FORMA BEAUTY SALON PARKING EXPANSION JSP26-14

Consideration at the request of Forma Beauty Salon for approval of the Preliminary Site Plan. The subject property is located at 26179 Novi Road, north of Grand River Avenue (Section 15). The applicant proposes site improvements including the addition of 10 parking spaces and a new dumpster enclosure.

PLANNING REVIEW

Review Date: May 20, 2026
Review Type: Combined Preliminary / Final Site Plan Review
Project Name: **JSP26-0014 FORMA BEAUTY SALON PARKING** (26179 Novi Road)
Plan Date: April 15, 2026
Prepared By: Diana Shanahan, Planner dshanahan@cityofnovi.org (248) 347-0483

JOB NO.: 1524
 SHEET: SP-2

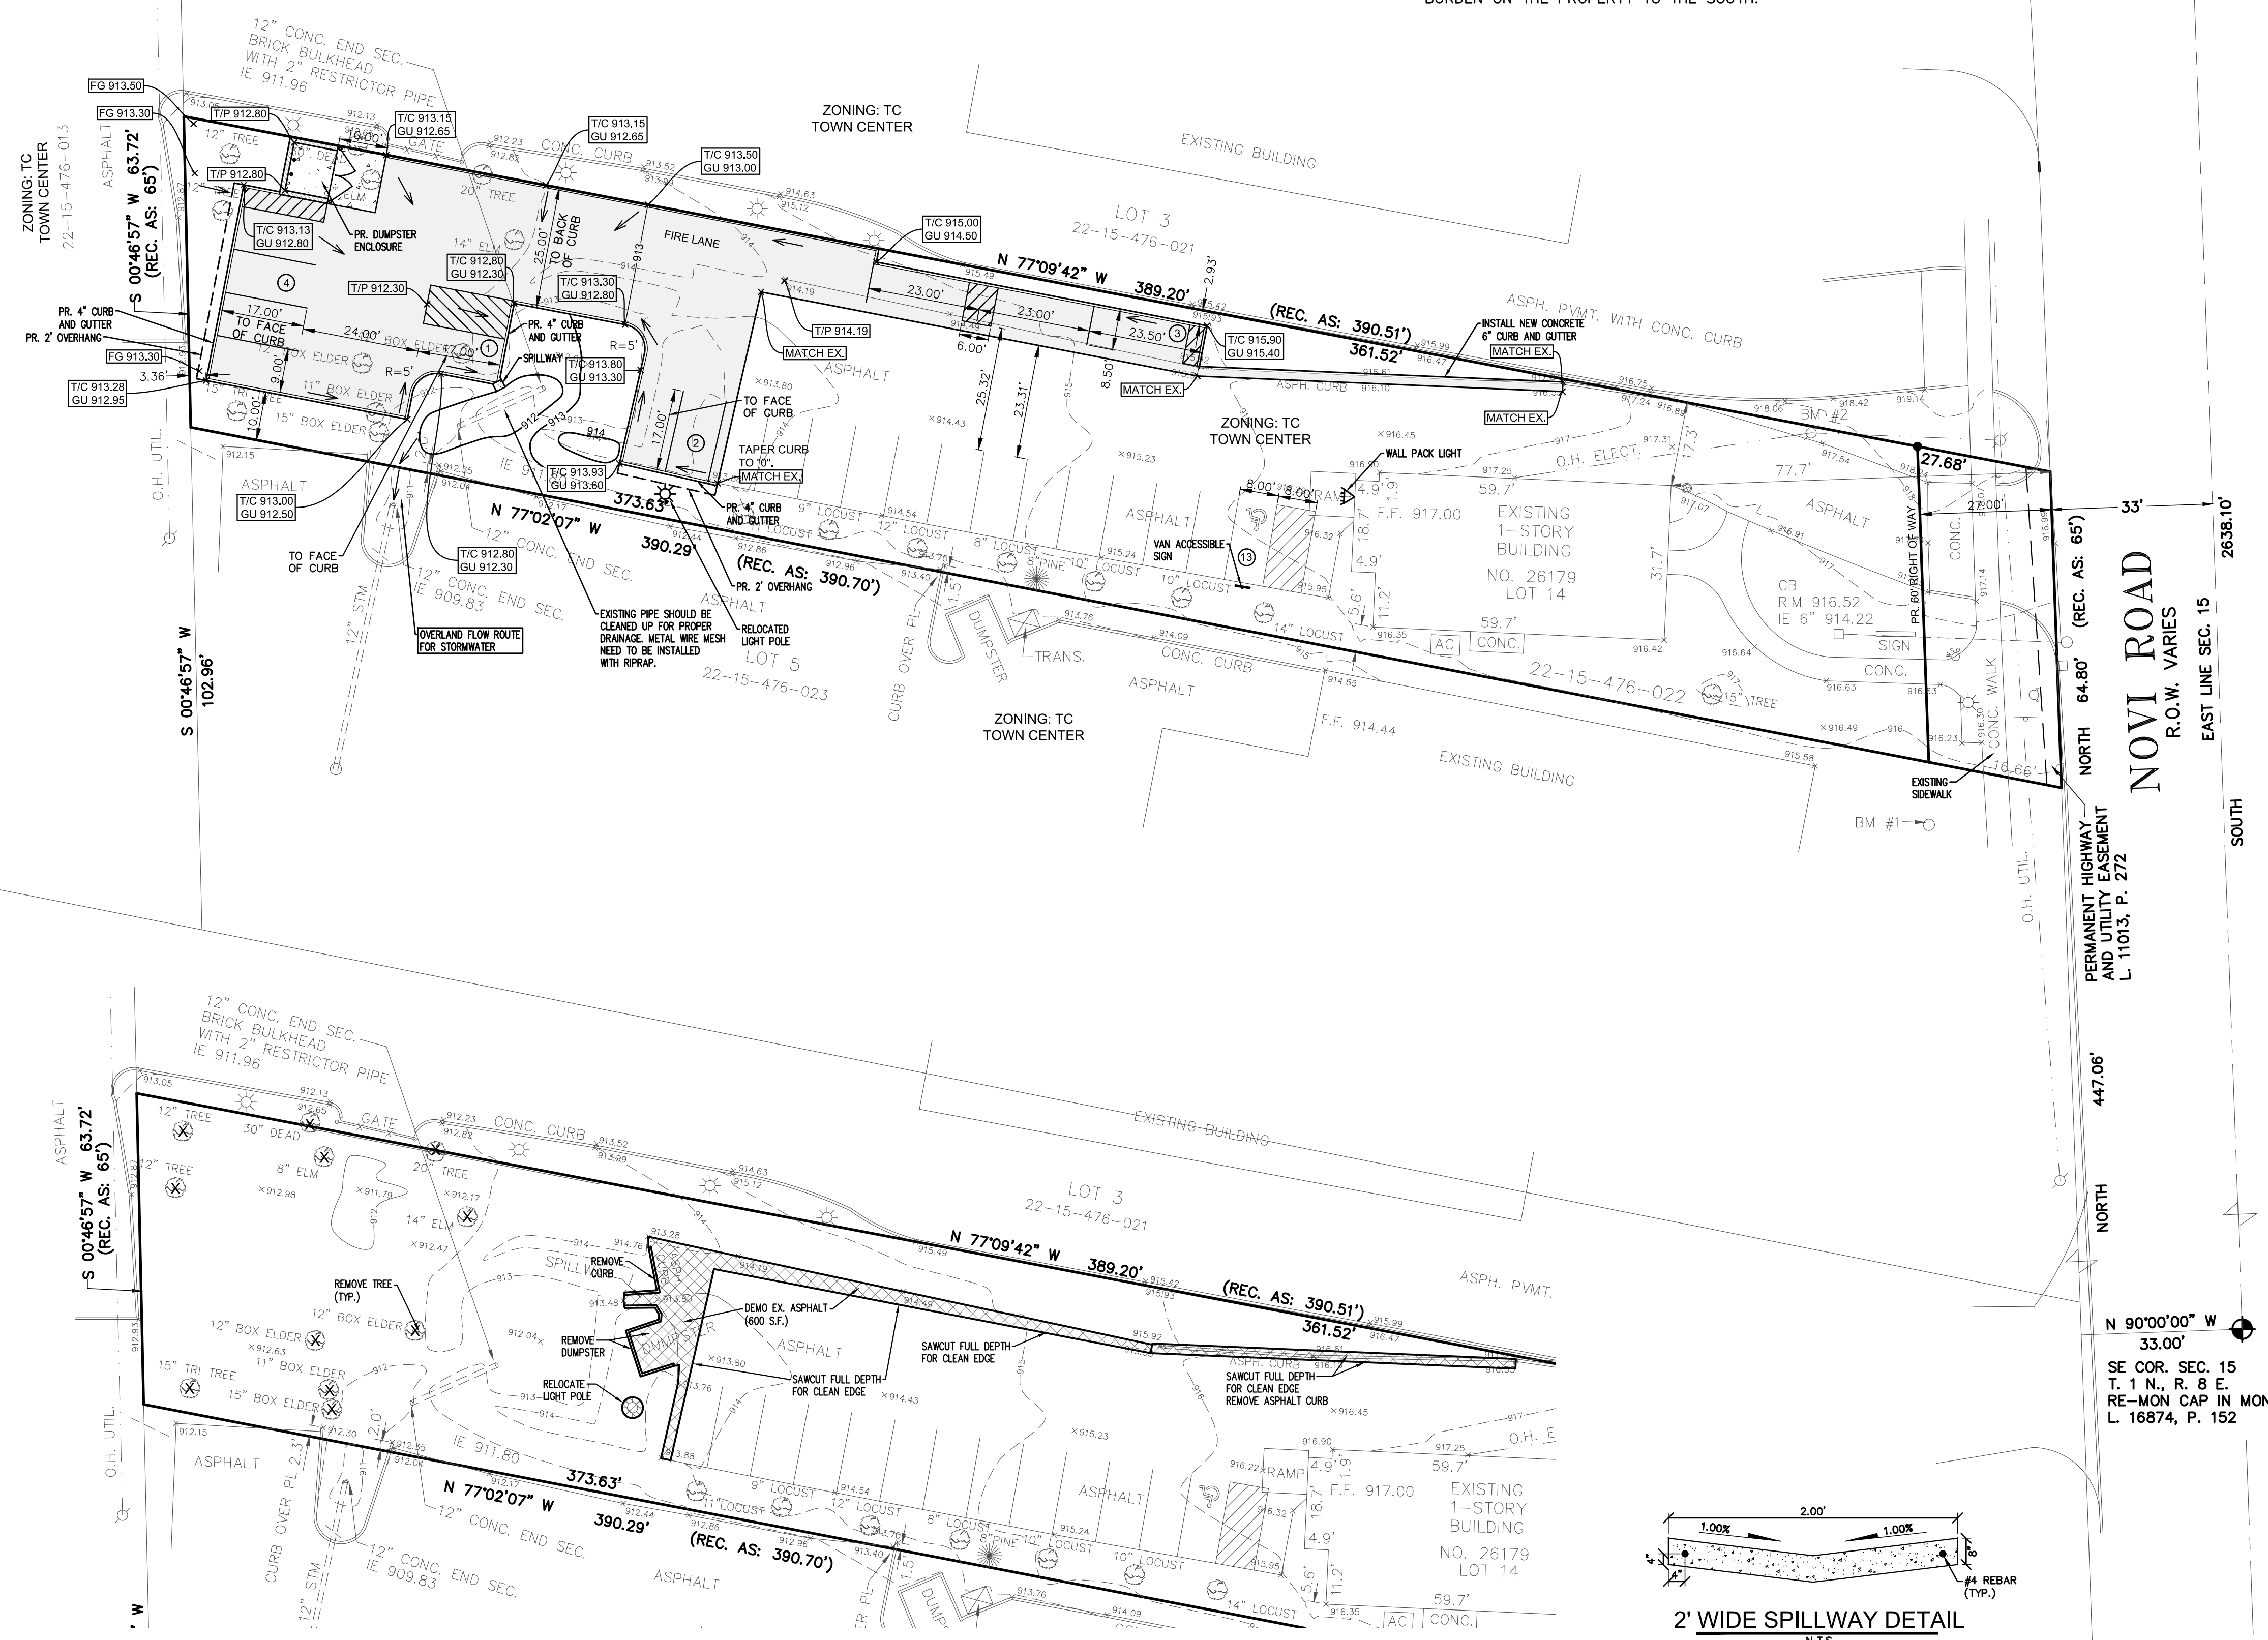
1. The Zoning Board of Appeals granting the following variances:
 - i. Section 3.1.25.D for deficiency in parking setback in the north side yard (20 feet required, 3 feet proposed) and rear yard (10 feet required, 3 feet proposed).

- ii. Section 4.19.2.F.iv for the location of the dumpster enclosure in the parking lot setback (10 feet setback required, 0 feet proposed).
2. A Landscape waiver under Section 5.5.3.C.iv.a for deficiency in parking lot perimeter trees (17 trees required, 15 trees provided) due to spatial limitations of the site which limit the ability to comply, which is hereby granted;

3. A Landscape waiver under Section 5.5.3.C.iv.b for deficiency in perimeter parking lot landscape area along north property line (10 feet required, 0 feet provided) due to spatial limitations of the site which limit the ability to comply, which is hereby granted;

DES. TLP
PROJECT NO. 26014
DWG NUMBER:
LS-1

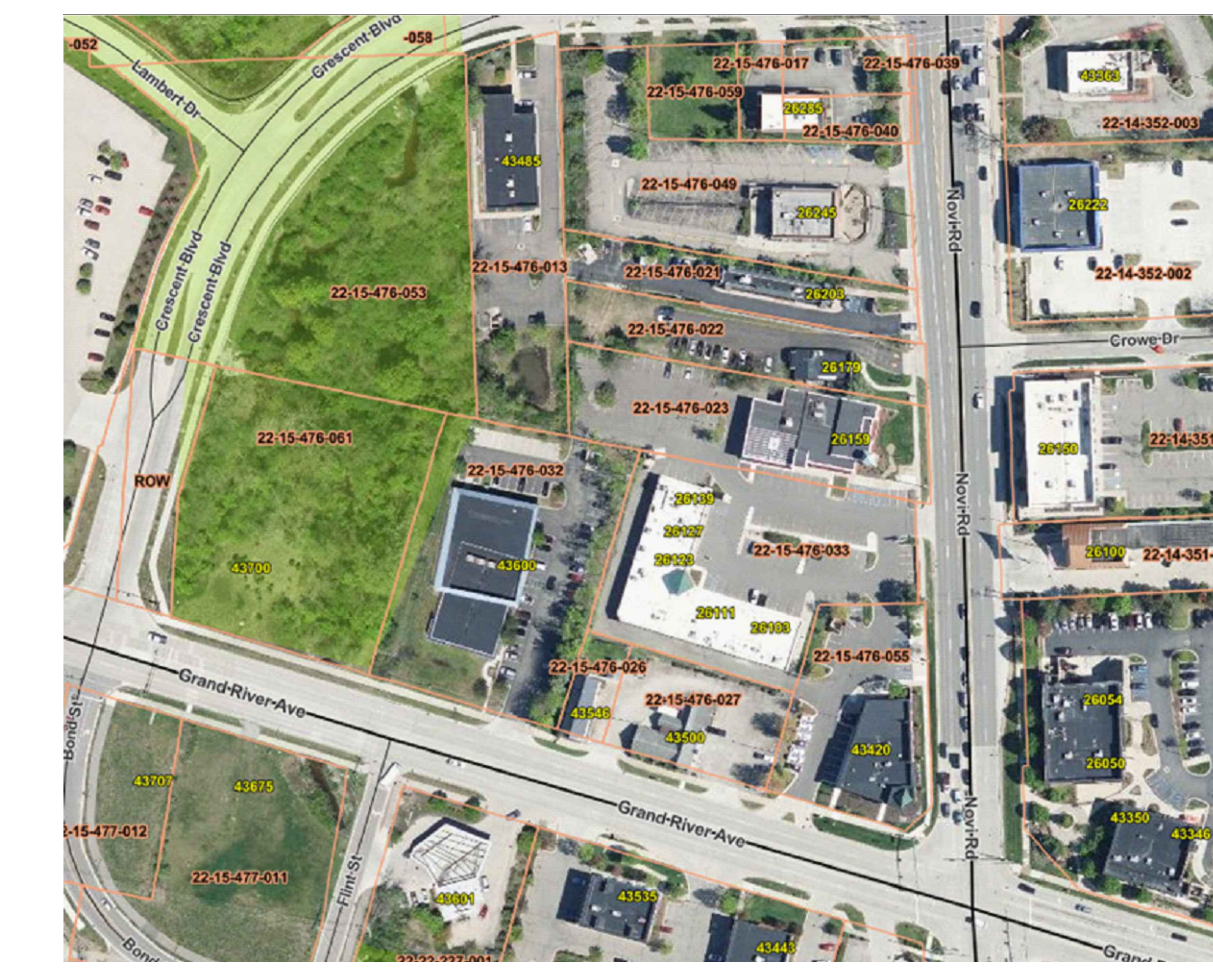
1. The required parking lot interior area is proposed but one more interior canopy tree is required to avoid needing a landscape waiver. **Please add that tree within the large interior island – there is room in the southwest corner of the island.**
2. The plan is deficient in parking lot perimeter trees by two trees so **a landscape waiver is required.** *Due to the spatial limitations of the site, the waiver is supported by staff, but the trees on the west end of the site must be moved as noted on the landscape chart.*

Number of canopy trees required	$D = C/200 = \text{xx Trees}$ $D = 885/200 = 4 \text{ trees}$	3 trees	No	Please add another interior tree and clearly mark it as such.
Parking Lot Perimeter Space (Zoning Sec 5.5.3.C.iv.b)	10-foot-deep landscape area along perimeter of lot	<u>0 feet for 179 feet along northern edge</u>	No	1. A landscape waiver is required. 2. <i>It is supported by staff due to the limitations of the site and the fact that all but two of the required perimeter trees can be provided along the available perimeter.</i>
Parking Lot Perimeter Trees (Zoning Sec 5.5.3.C.iv.b)	1 Canopy tree per 35 lf $600/35 = 17 \text{ trees}$ 225lf of parking lot does not have required 10-	<u>13 trees</u> 5 new trees + 8 existing trees Serviceberries cannot count as a perimeter tree	No	1. Please indicate the perimeter for the entire parking area with a heavy line. It can be the green line on the image below, less the southern

Merjent visited the Site on May 15, 2026 to observe conditions on-site relative to the provided PSP/FSP. The feature labeled "POND" on the submitted landscape plan (LS-1) is located in the southwest corner of Lot 4 and contains an engineered spillway and 4-inch restrictor pipe. Merjent found conditions on-site consistent with a very small constructed stormwater detention basin with no wetland vegetation present; the area immediately surrounding the feature consisted of cover dominated by Kentucky bluegrass (*Poa pratensis*), red fescue (*Festuca rubra*), common/English plantain (*Plantago major*), and common dandelion (*Taraxacum officinale*), consistent with common lawn seeding in a maintained upland setting. No hydrophytic vegetation, wetland hydrology indicators, standing/ponded water, or other surficial wetland characteristics were observed at the time of the site visit. The area receives incidental runoff from the adjacent parking lot but does not exhibit surface inundation, saturation, or other primary or secondary wetland hydrology indicators, aside from geomorphic position.

1. The feature labeled "POND" on the submitted landscape plan (LS-1) is consistent with a constructed stormwater detention basin based on the presence of engineered outlet control infrastructure (spillway and 4-inch restrictor pipe) and the absence of wetland vegetation, hydrology indicators, or wetland soils as observed during the May 15, 2026 site visit. Pursuant to MCL 324.30305(4)(b) and the definition of "watercourse" under Section 12-152 of the City's Code of Ordinances, this feature does not constitute a regulated wetland under Chapter 12, Article V. Accordingly, no wetland permit is required from the City of Novi for this Project. The applicant should provide documentation of the

original site plan approval and/or stormwater management plans associated with this feature at the time of final site plan approval to support this determination. The City may also have copies of the approved drainage designs on file.

26179 NOVI RD. - FORMA SALON
 EXTERIOR PHOTOMETRIC PLAN
 GASSER BUSH ASSOCIATES
 WWW.GASSERBUSH.COM

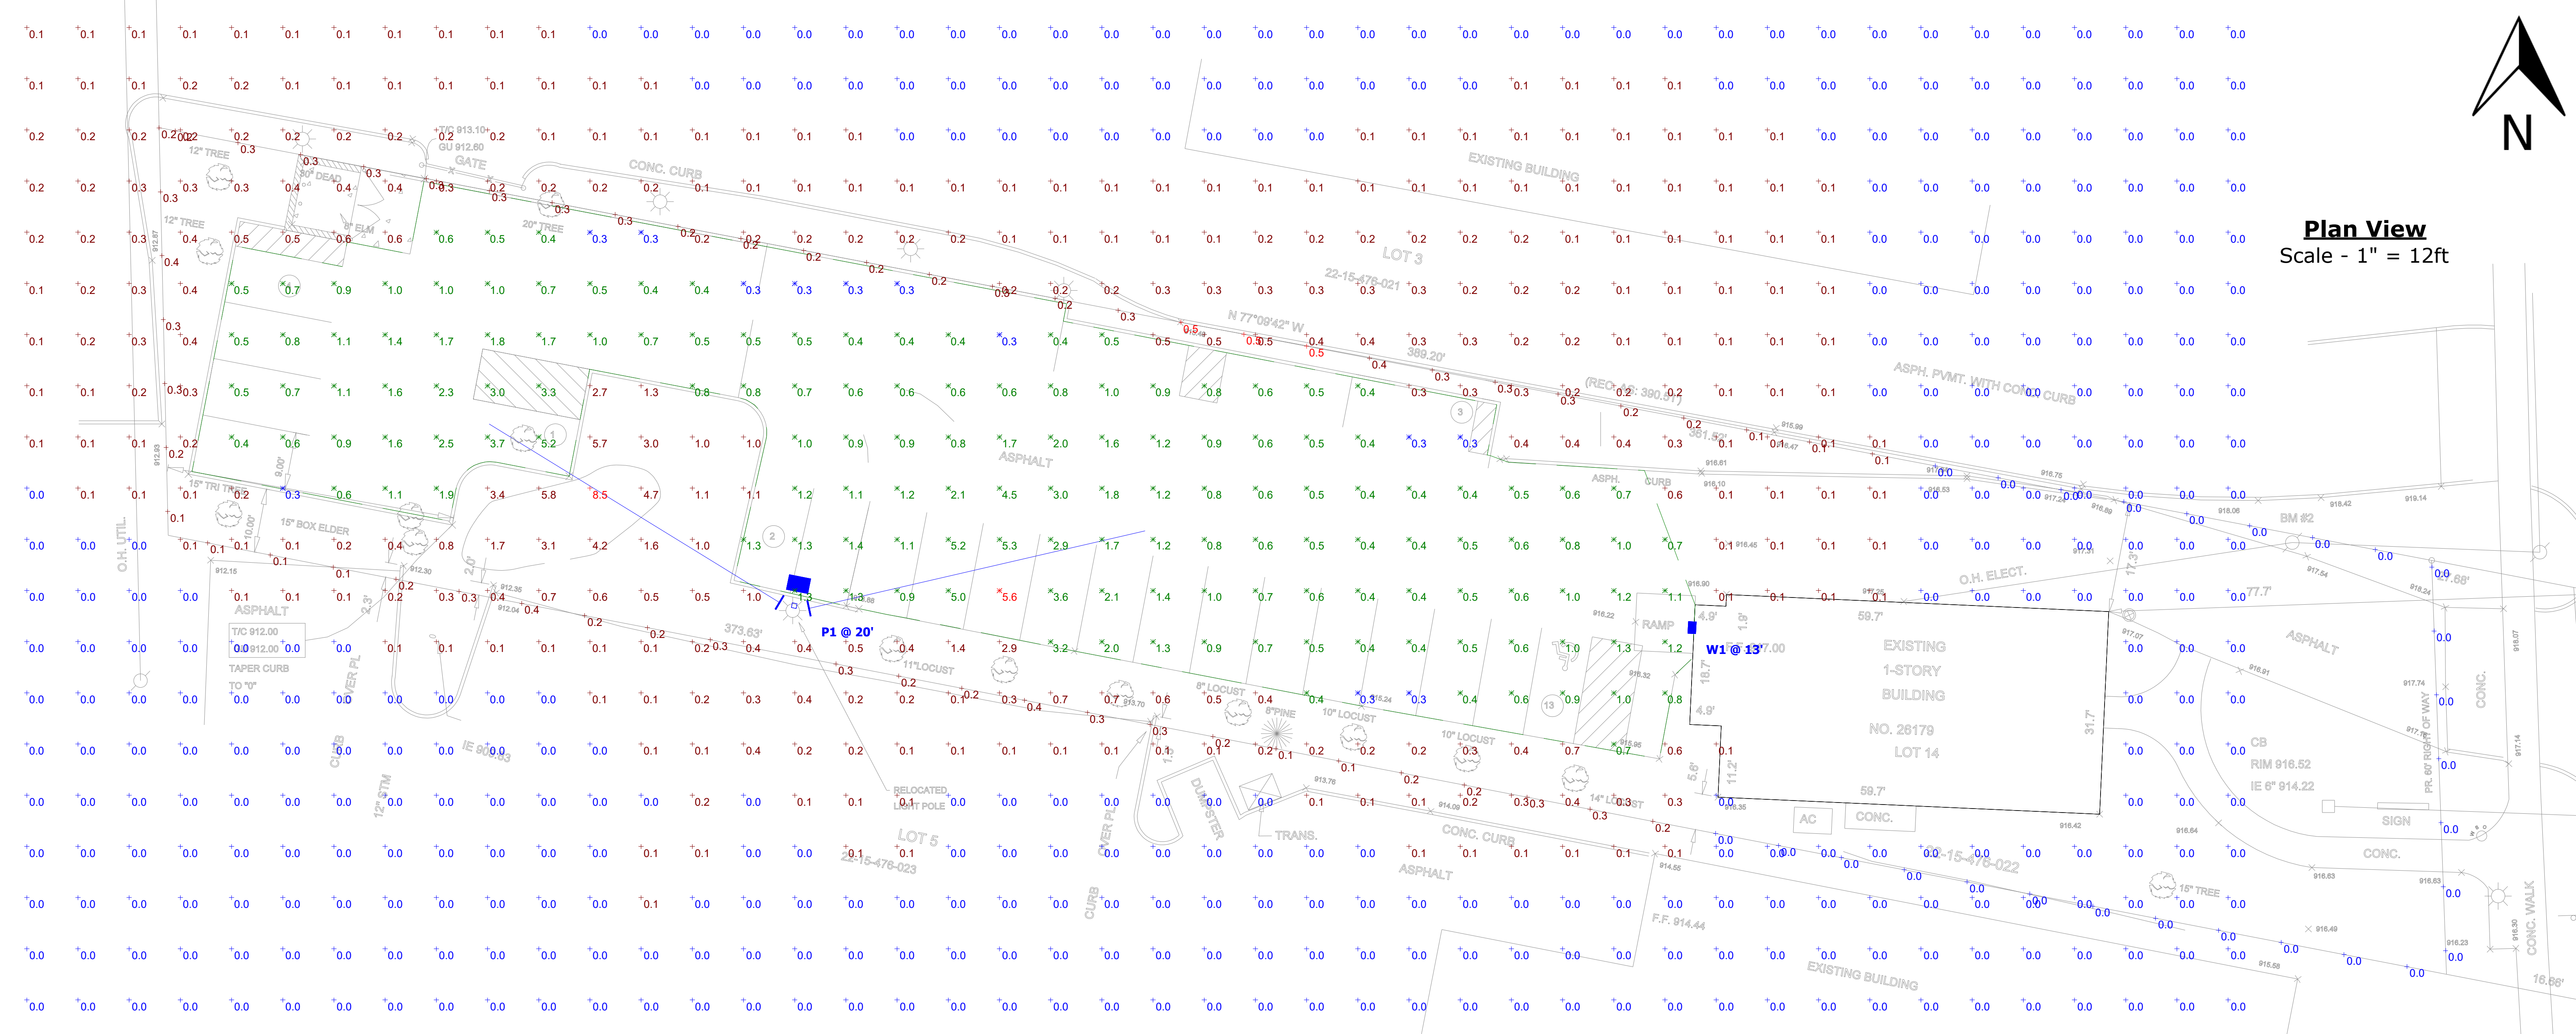
5. Lighting and Photometric Plan (Section 5.7): A lighting and photometric plan was provided; however additional information is required for these items. Refer to Planning Review Chart for additional information.
6. Planning Review Chart: The Planning Review Chart provides additional comments and requests clarification for certain items. Please address these items in addition to the comments provided in this letter.

Item	Required Code	Proposed	Meets Code	Comments
Roof Top Appurtenances Screening (Section 4.19.2.E.ii)	Rooftop equipment may not exceed the district height limit unless set back 5 ft per ft of excess height, with a maximum 5-ft extension. Equipment to be screened and hidden from streets and neighboring properties	None proposed	N/A	
Lighting and Photometric Plan (Section 5.7)				
Lighting Plan (Section 5.7.2.A.i)	A lighting plan showing location of all existing and proposed buildings, landscaping, streets, drives, parking areas and exterior lighting fixtures	Photometric provided	Yes	Clearly indicate parcel boundaries on photometric plan
Photometric Plan (Section 5.7.2.A.ii)	Provide a photometric plan illustrating the levels of illumination at ground level accounting for all light sources that impact the subject site. Include specifications for all proposed and existing lighting fixtures	Photometric provided	TBD	Remove rows on schedule for any symbols not used Add photometric calculations for light fixture on Novi Road and building lighting

Building Lighting (Section 5.7.2.A.iii)	Relevant building elevation drawings showing all fixtures, the portions of the walls to be illuminated, illuminance levels of walls and the aiming points of any remote fixtures		TBD	Add any existing or proposed building lighting to the photometric plan
Maximum Height (Section 5.7.3.A)	Height not to exceed maximum height of zoning district	20 feet	Yes	
Electrical Service (Section 5.7.3.B)	Electrical service to light fixtures must be underground	Note on SP-2	Yes	
Flashing Light (Section 5.7.3.C)	No flashing light permitted	Note on SP-2	Yes	
Glare Control (Section 5.7.3.D)	Shall be accomplished through the proper selection and application of lighting equipment.		TBD	Indicate any glare control devices
Outdoor Lighting: Average Light Levels (Section 5.7.3.E)	Average light level of the surface being lit to the lowest light of the surface being lit shall not exceed 4:1 foot-candles	3.7:1	Yes
